# UNITED STATES PATENT AND TRADEMARK OFFICE

APPLICATION NO.	FILING DATE	FIRST NAMED INVENTOR	ATTORNEY DOCKET NO.	CONFIRMATION NO.
10/743,424	12/23/2003	Yunggyo Lee	031345	7516

**Office Action Summary**

## DETAILED ACTION

FIG. 1

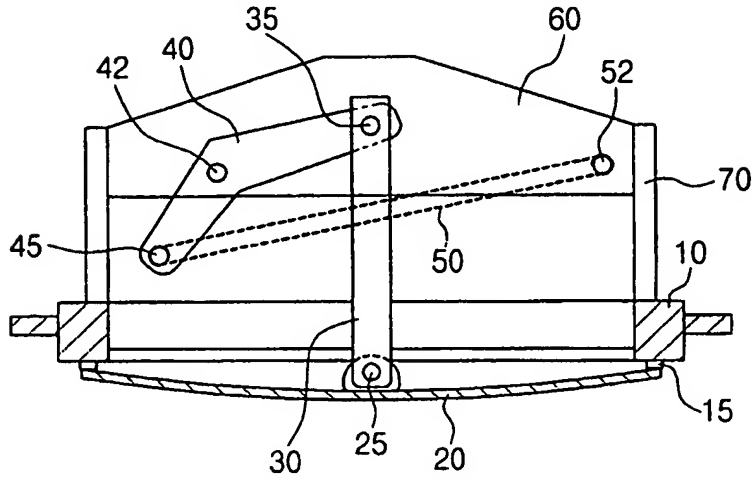
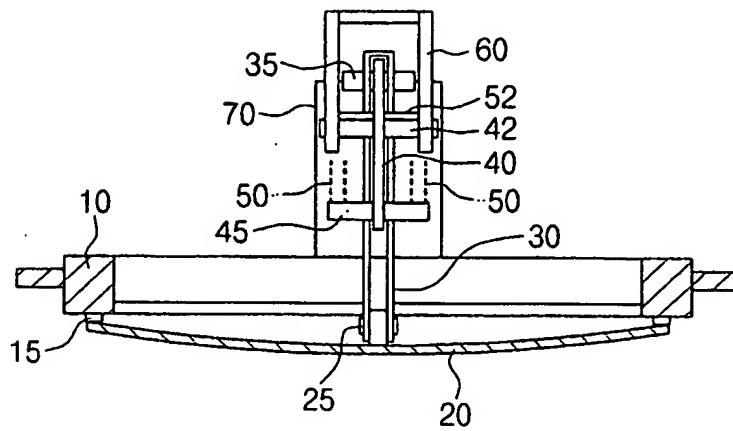
4. Claims 1-7 are rejected under 35 U.S.C. 103(a) as being unpatentable over applicant's admission to the prior art (APA) as shown in Figures 1 and 2, in view of Chlebek et al. (US 5,513,395).

APA discloses a safety valve operated by differential pressure, the valve comprises of a valve body (10), a valve disk (20), a central link (30), a link (40), an elastic member (50), the valve disk (20) being mounted on the valve body (10), the central link (30) being connected at one end to the valve disk (20), and opening and closing the valve, the link (40) being connected pivotally at one end to the central link (30), and making the central link (30) move according to rotation of the link (40) around a link pivot (42), the elastic member (50) being connected pivotally at one end to the link (40,45) and fixed pivotally at the other end (52), and making the link rotate around the link pivot (42) by elastic force of the elastic member (50), the member being mounted on the other end of the central link (30).

APA lacks a non-magnetic member attracted by a magnet.

It would have been obvious to one of ordinary skill in the art at the time the invention was made to provide the magnet of Chlebek et al. onto the frame of APA and the non-magnetic member of Chlebek et al. onto the central link of APA, in order to

have a magnetic attraction force that holds the non-magnetic member firmly up in a closed position, as taught by Chlebek et al. in Figures 3 and 4 and in (col. 3, Lns. 50-56),

Regarding claim 2, APA discloses a gasket (15) located between the valve body (10) and the valve disk (20).

Regarding claim 3, APA discloses the elastic member is a spring (50).

Therefore, it would have been an obvious matter of design choice to modify the prior art as shown in Figure 1 and 2 in view of Chlebek et al. to obtain the invention specified in claim 5.
